**COLCHESTER BOROUGH COUNCIL  
PLANNING COMMITTEE  
1 November 2012 at 6:00pm**

<b>Report of</b>	<b>Head of Environmental &amp; Protective Services</b>	<b>Author</b>	<b>Alistair Day</b> ☎ 01206 282479
<b>Title</b>	<b>Construction of a new 300 place primary school with external hard and soft play areas, canopy and 20 space car park.</b>		
<b>Wards affected</b>	<b>New Town</b>

Contact: Alistair Day  
Phone: 01206 282479 Fax: (01206) 282598  
E-mail: [planning.services@colchester.gov.uk](mailto:planning.services@colchester.gov.uk)  
Your ref: CC/34/12/COL  
Our ref: 121762  
Date: 24 October 2012

**Proposal:** Construction of a new 300 place primary school with external hard and soft play areas, canopy and 20 space car park.

Proposed West Elevation

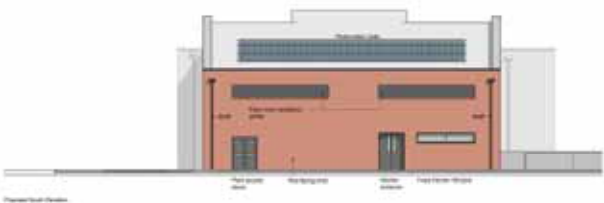
The west elevation of the teaching block is composed of a series of unarticulated asymmetrical gables which create a saw tooth roof pattern. The roof of the school is an alien form within the Garrison Conservation Area and appears visually very ‘aggressive’ when compared to the roofs of the historic garrison buildings. It is acknowledged that gables are a feature of many of the surrounding buildings; however the method in which they are employed is totally different – i.e. the gables are expressed / articulated and well ordered. The west elevation of the classroom block is clad in red brick with vertical banding of gault brick used to break down the form / bulk of the elevation. The resulting effect of the contrasting brickwork, the arbitrary brick diamond pattern and the random window arrangement, all combine to create an elevation that lacks visual repose.

The main entrance on the west elevation is set at the junction of the recess between the classroom block and hall / communal area. The entrance, by virtue of its siting, width and general design, is not clearly expressed and, as such, lacks an immediate presence when viewed from the street. It is noted that amended drawings have been submitted that seek to improve the approach to the entrance school; however these amendments do not address the fundamental issues associated with the design of the actual entrance. The roof form of the hall / service block is composed of a stretched asymmetrical gable which is adjoined to a flat roof. The asymmetrical gable is constructed approximately of 2/3 redbrick and 1/3 gault brick and incorporates windows that have a stronger vertical emphasis (when compared to the teaching block); the remainder of the building is constructed of red brick and has no articulation or visual interest.

The east elevation of the school adopts a similar composition / detailing to the west elevation; the classrooms are however articulated on this elevation which helps considerably in terms of breaking-up the visual mass of this part of the building.

In short, the saw-tooth roof gives the building something of a warehouse feel whilst the detailing of the elevations appear akin to dwelling houses that were frequently produced in

the 1960 / 70s as a part of the New Town expansion programme; what the proposed building does not appear as is a school.
